*Drainage Report
for*

*Tijeras Heights
Subdivision*

Re: Drainage Plan for Tijeras Heights Subdivision

RE: Tijeras Heights

FIGURE 3

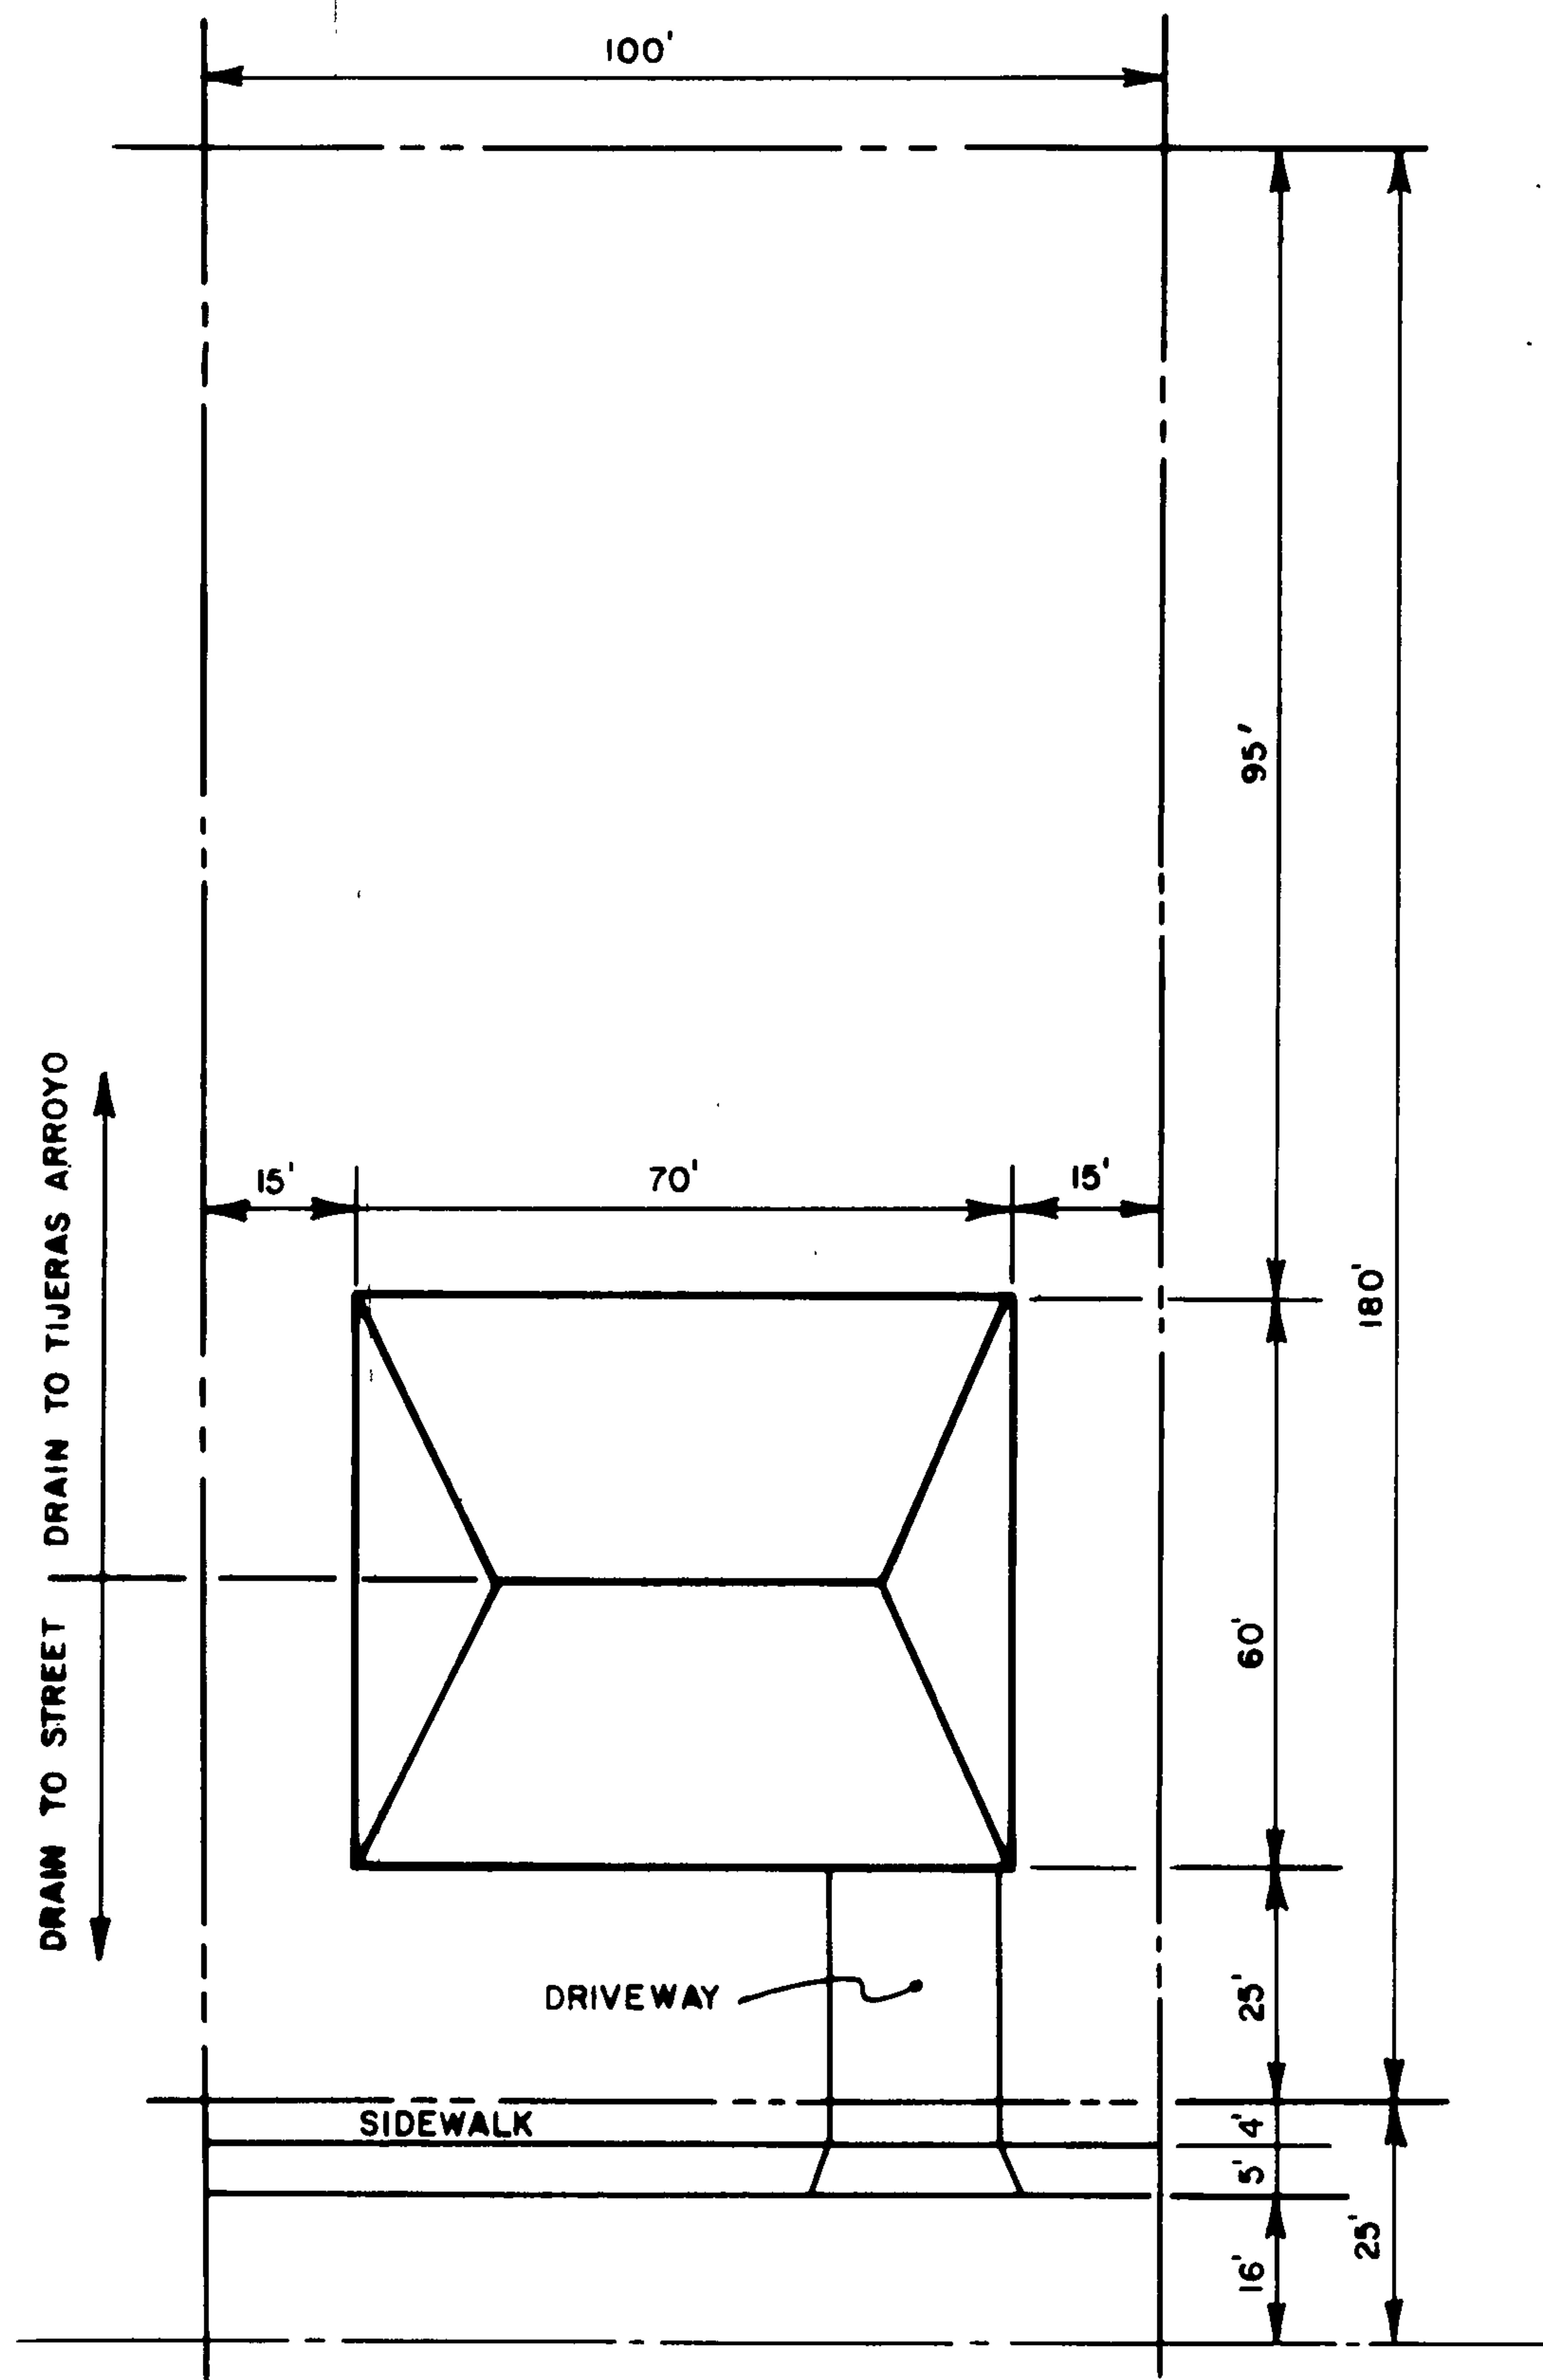
The drainage provision for Tijeras Heights Subdivision are generally acceptable except for the recommendation of allowing the runoff from the rear lots to flow over the embankment and directly into the Tijeras Arroyo. The discharge of the runoff into the Arroyo is not objectionable in itself, rather the possibility of gullying and erosion of the steep bank. For instance as shown on Figure 4 of the drainage report Lots 1,2,5,6 & 18 appear to be particularly susceptible to damages. I would therefore like to receive an addendum indicating a positive method of control of the potential erosion problem.

1. A note will be placed on the final plat stating -
"All front yards and roofs shall drain to Piru Blvd.
and drainage from rear yards shall not form a concentrated discharge but shall remain as sheet flow when draining to the arroyo".
2. The developer will not dedicate the flood plain to AMAFCA at this time.
3. The developer intends to retain the bank of the arroyo as open space.
4. AMAFCA concurs with the drainage plan as submitted and modified herein.
